SUBJECT: HOMESTAKE MINING COMPANY OF CALIFORNIA, U.S. NUCLEAR REGULATORY COMMISSION REQUEST FOR ADDITIONAL INFORMATION, REVISED REQUEST FOR AMENDMENT TO CHANGE THE BACKGROUND MONITORING LOCATION FOR RADON AND AMBIENT GAMMA RADIATION, LICENSE NO. SUA-1471, DOCKET 040-08903

**U.S. Nuclear Regulatory Commission Request for Additional Information
Homestake Mining Company of California, Revised Request for Amendment to
Change the Background Monitoring Location for Radon and Ambient Gamma
Radiation, Grants Reclamation Project Materials License SUA-1471**

Request for Additional Information (RAI) -1

Figure 1. Surface water drainages in the vicinity of the GRP (from Figure 3.1-1 in HMC, 2012)

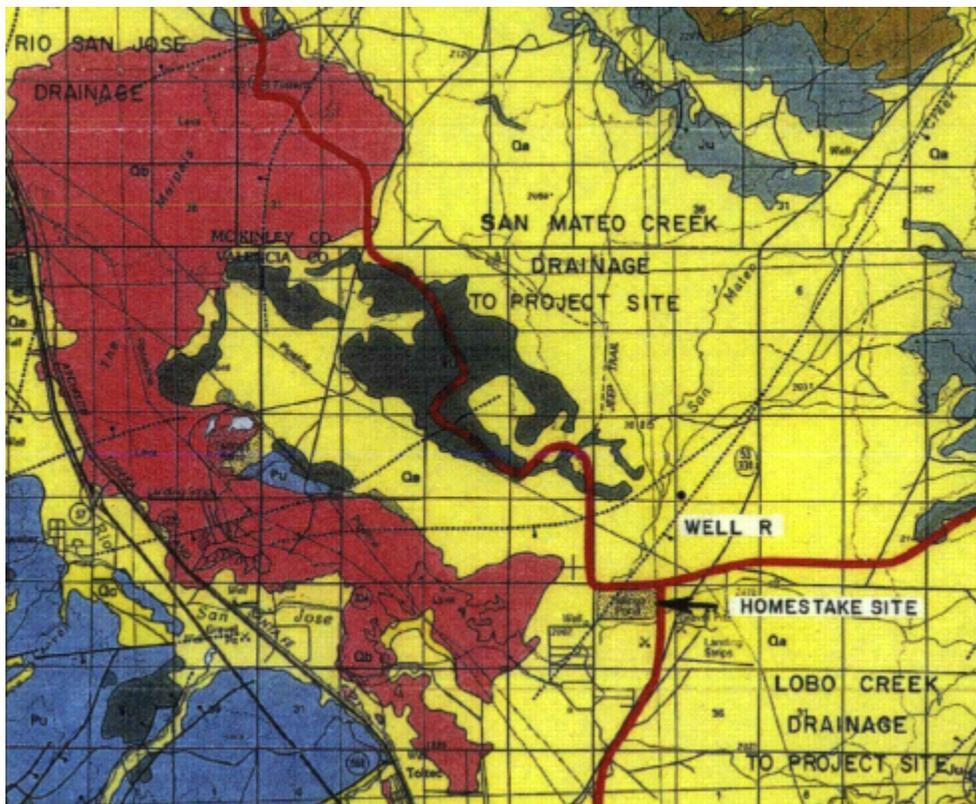
The U.S. Nuclear Regulatory Commission (NRC) staff reviewed geological (HMC, 2012) and hydrogeological (Hoffman, 2001) descriptions of the general area of the Grants Reclamation Project (GRP). Figure 1 below shows the extent of the alluvial deposits in the SMC basin as well as the SMC, Lobo Creek, and Rio San Jose surface water drainages. The report by Hoffman (2001) describes the San Mateo alluvial system as following "...the San Mateo alluvium and drainage system and extends from the northeast of the site to the south and west."

Figure 2. Alluvial plain in the vicinity of the GRP with environmental monitoring stations as described by HMC (from Figure 8 of Attachment 1 to HMC, 2020a)

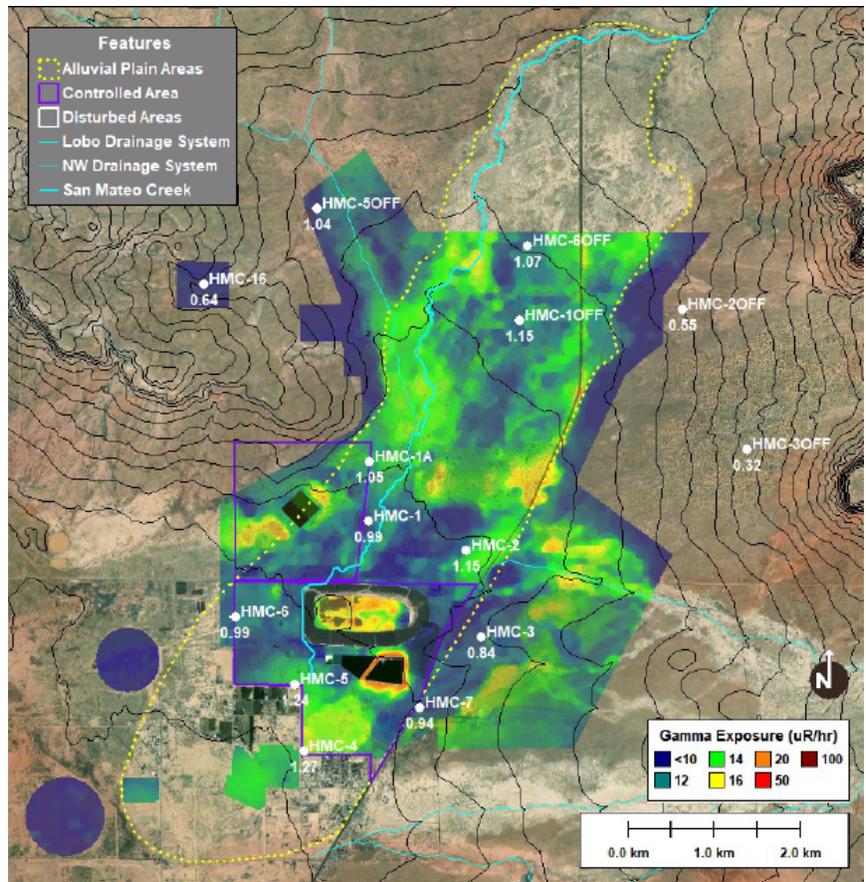
Provide a justification for confining the alluvial plain to the San Mateo Creek (SMC) alluvial plain as indicated in Figure 7 of Attachment 1 to the Homestake Mining Company of California (HMC or licensee) December 2020 submittal (HMC, 2020a).

Figure 2 (below) shows the alluvial plain as defined by HMC and used in its evaluation of proposed background radon monitoring stations.

Figure 3. NRC staff's representation of the alluvial plain with maximum elevation of 2,023 m (green outline), northeast to southwest elevation (blue line and bottom elevation profile), and east-west "flat" areas (i.e., relatively small elevation changes) (red lines).

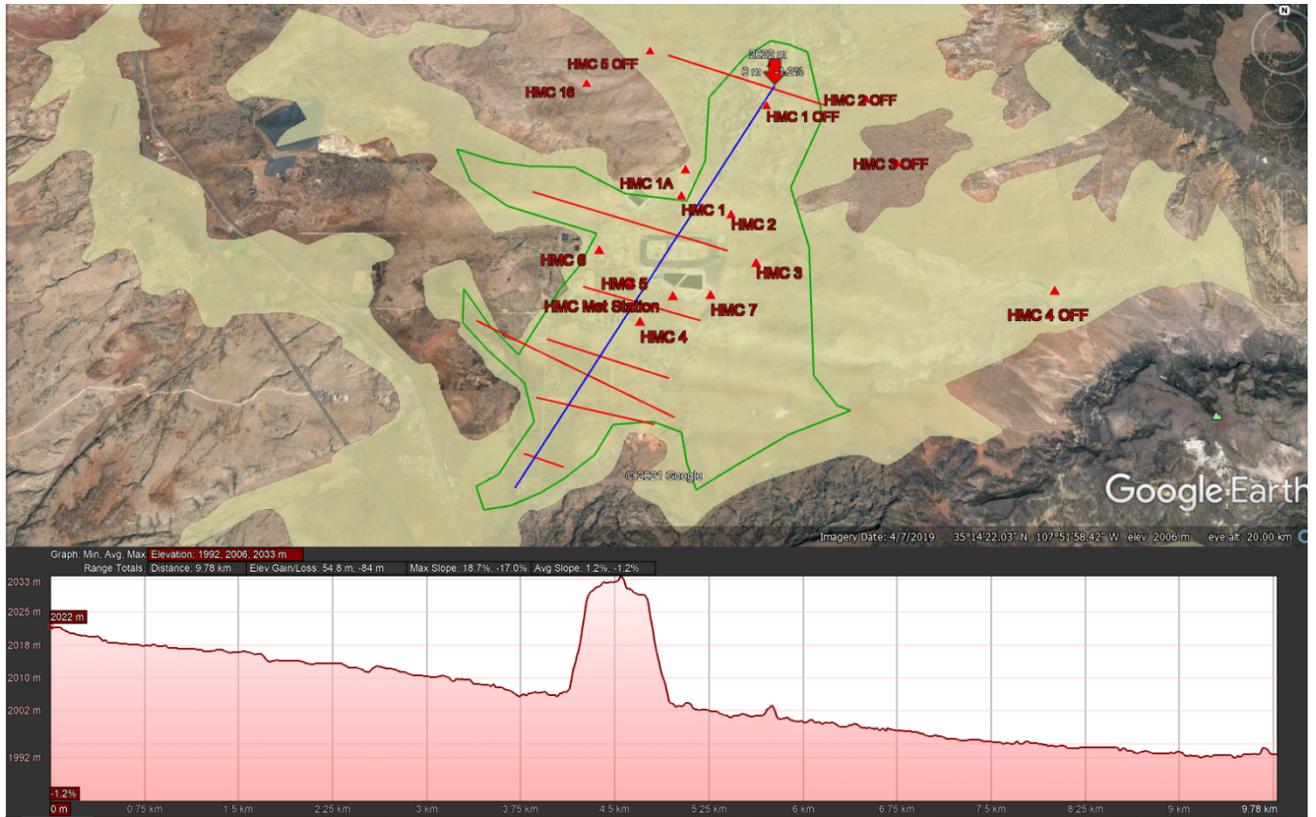
Using data from the United States Geological Survey (USGS, 2021a), the NRC staff evaluated the geology and topography in the vicinity of the GRP using Google Earth Pro. The green outline area in Figure 3 below represents the NRC staff's interpretation of a broader alluvial plain based on reported alluvium deposits (yellow shaded area) in the vicinity of the GRP. For comparison purposes, the maximum elevation around the perimeter is approximately 2,023 meters (m) (6,637 ft) to coincide with HMC's proposed HMC-6OFF location.

The NRC staff notes that the northeast to southwest line through the San Mateo drainage (the blue line in Figure 3) continues decreasing in elevation. The elevation change between HMC-6OFF and the current monitoring station HMC-4 is approximately 23 m (75 ft) [21m (69 ft) for HMC-1OFF]. HMC-6OFF is approximately 6.5 kilometers (km) [4 miles (mi)] from HMC-4. HMC-1OFF is approximately 5 km (3.1 mi) from HMC-4. As indicated in Figure 3, the elevation begins to flatten out around HMC-4 and decreases approximately another 8 m (26 ft) between HMC-4 and the southwestern end of the blue line in Figure 3.

If this is the case, then the effects of topography and inversion conditions on radon concentrations will not be limited to HMC's depiction of the alluvial plain. The migration of radon will continue south and west of the GRP in the broader area representative of HMC-4 and HMC-5.

As indicated in Figure 3, HMC-1OFF and HMC-6OFF are generally closer to the upland areas of the San Mateo alluvial plain than HMC-4 and HMC-5. According to HMC (2020a), this area is a source of radon contributing to higher radon concentrations on the alluvial plain floor. However, the NRC staff considered the greater alluvial plain area in the vicinity of HMC-4 and HMC-5 (i.e., a greater area over which the pooled radon can dissipate), and that HMC-4 and HMC-5 are located further from these upland sources (see Figure 3). Taking into account the lower elevation of HMC-4 and HMC-5 relative to HMC-1OFF and HMC-6OFF, as discussed above, it is not clear to the NRC staff that HMC-1OFF and HMC-6OFF are representative of these current monitoring locations.

Figure 4. Legacy uranium mines in the vicinity of the GRP.

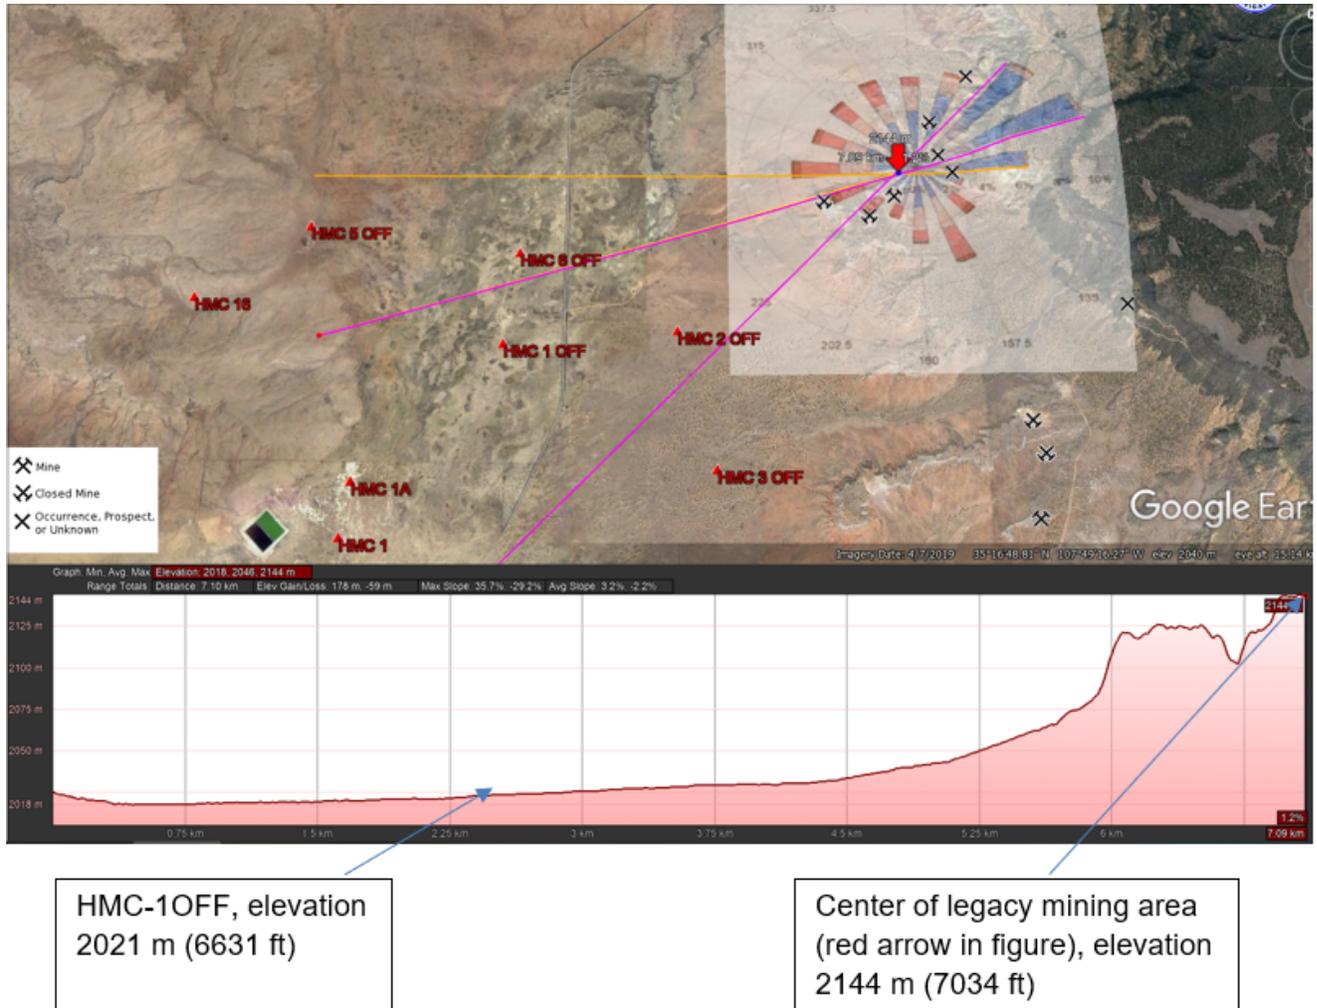
From Figure 4, HMC-1OFF appears to be downgradient from the two sectors (the purple lines in the figure) representing the largest percentage of drainage flow conditions as identified by HMC (i.e., more stable wind conditions). Adding the third highest sector (the orange line in the figure) also encompasses HMC-6OFF. It does not appear to the NRC staff that these sources were specifically evaluated previously by other authors or currently by HMC.

The NRC staff is not aware of available data to determine if there is any effect from these uranium sources on HMC-1OFF or HMC-6OFF. However, it is highly unlikely that there would be any impact at HMC-4 and HMC-5 due to the additional distance from these sources.

Figure 5. Predicted concentration normalized to HMC-16 for the case of enhanced radon flux in San Mateo Wash and based on 2017 Met data (from Figure 15 in Attachment 2 to HMC, 2020a)

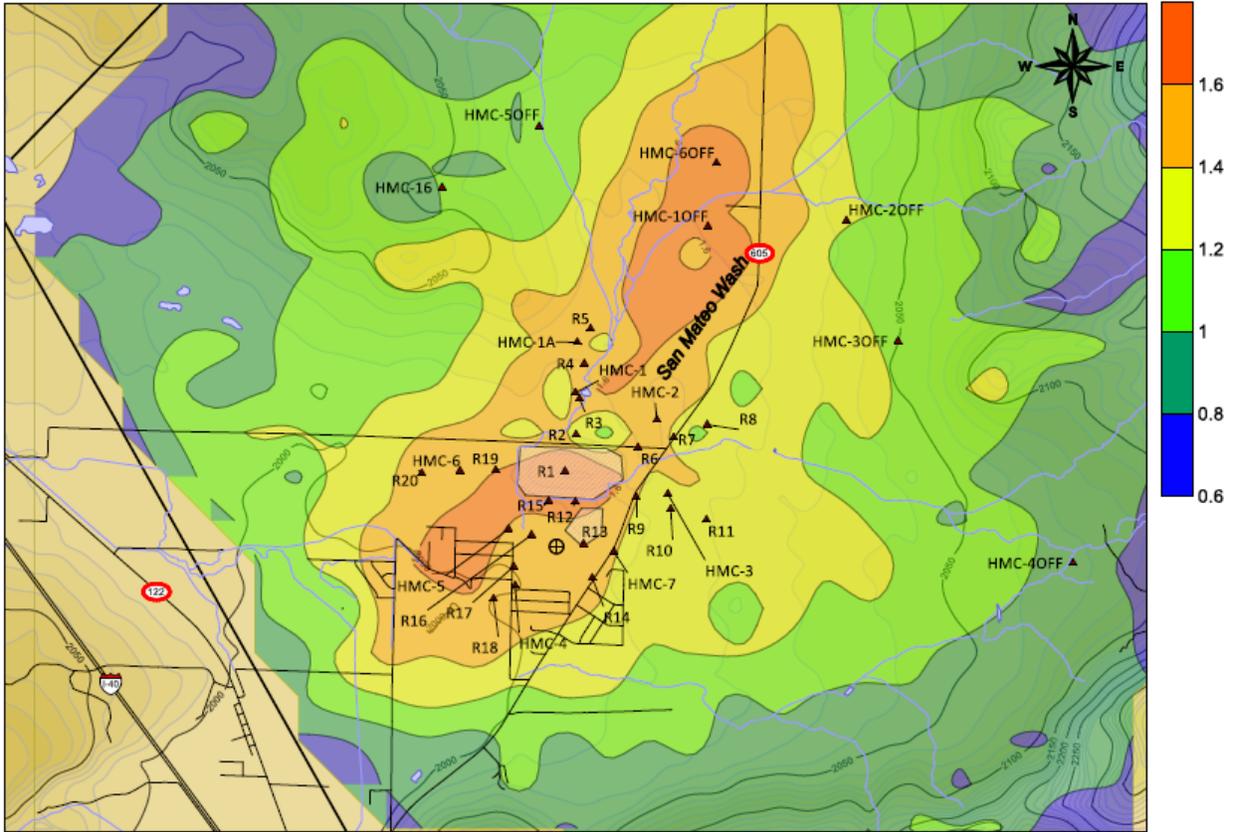
In addition, the NRC staff evaluated Figure 5 and notes that HMC-1OFF and HMC-6OFF are modeled as higher predicted radon concentrations relative to HMC-4 and HMC-5. The NRC staff recognizes that the main purpose of the figure was to demonstrate differences between radon concentrations on the upland slopes and the floor of the alluvial plain. However, any proposed background stations that are modeled as having higher background radon concentrations than the point(s) of compliance for public dose assessment (i.e., HMC-4 and HMC-5) should be cause for reexamining the CSM and evaluating any changes to the CSM, or additional data collection needs, or both.

HMC recognized the importance of this type of normalized data analysis in its response to a previous NRC staff Request for Additional Information (RAI) (see HMC response to RAI No. #2b in HMC, 2014). Furthermore, the modeling results in Figure 5 incorporate some, but not all, of the factors influencing radon concentrations at HMC-1OFF as discussed by HMC (see HMC response to RAI No. #9b in Attachment 3 to HMC, 2020a). For example, Figure 5 does not include an estimated effect of known localized radon sources that could potentially increase the differences between HMC-1OFF and other monitoring stations.

Figure 6. Soil type north of the GRP LTP (USDA, 2021)

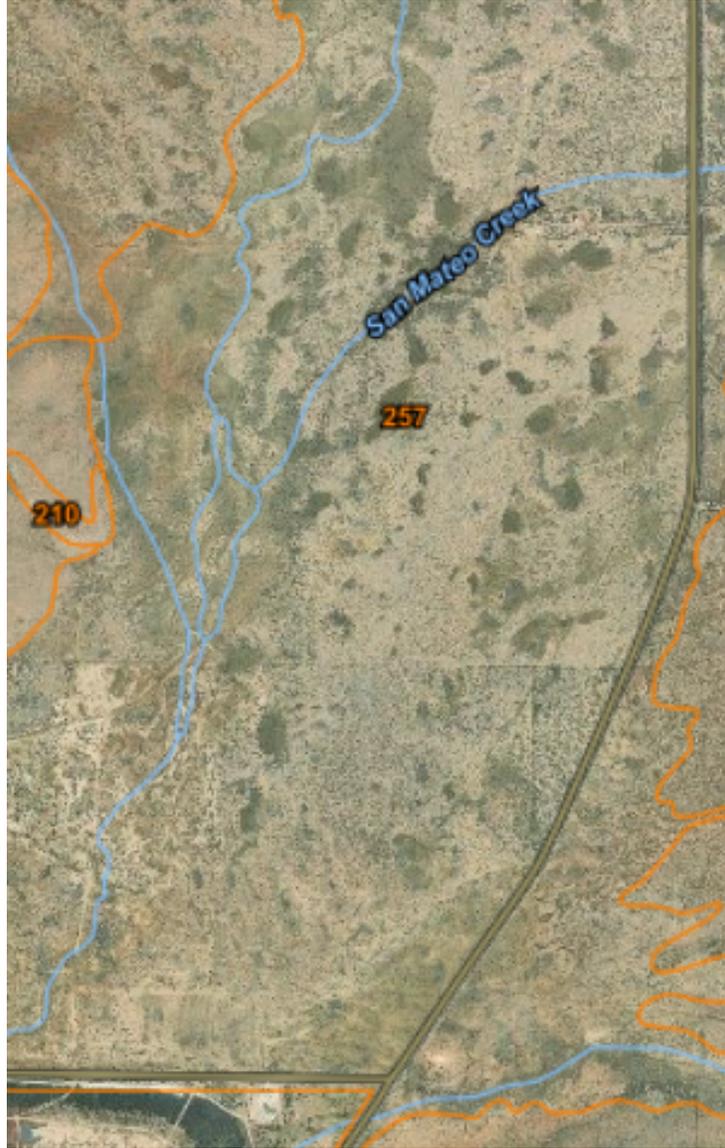
The NRC staff utilized the online Web Soil Survey (U.S. Department of Agriculture [USDA], 2021) to visualize the soil types in the vicinity of the GRP. As Figures 6 and 7 show, there is basically one soil type in the relevant area north of the large tailings pile (LTP) (Type 257) where the proposed HMC-1OFF and HMC-6OFF are located. South of the LTP, including HMC-4 and HMC-5, there are a variety of different soil types. These soil types may be very similar in their ability to impact the exhalation of radon gas from the soil surface; however, considering the importance of local soils in HMC’s stated CSM, and the fact that the proposed background locations reside in soil types different from the locations of public dose compliance (i.e., HMC-4 and HMC-5), HMC should analyze any differences and potential impacts to the CSM.
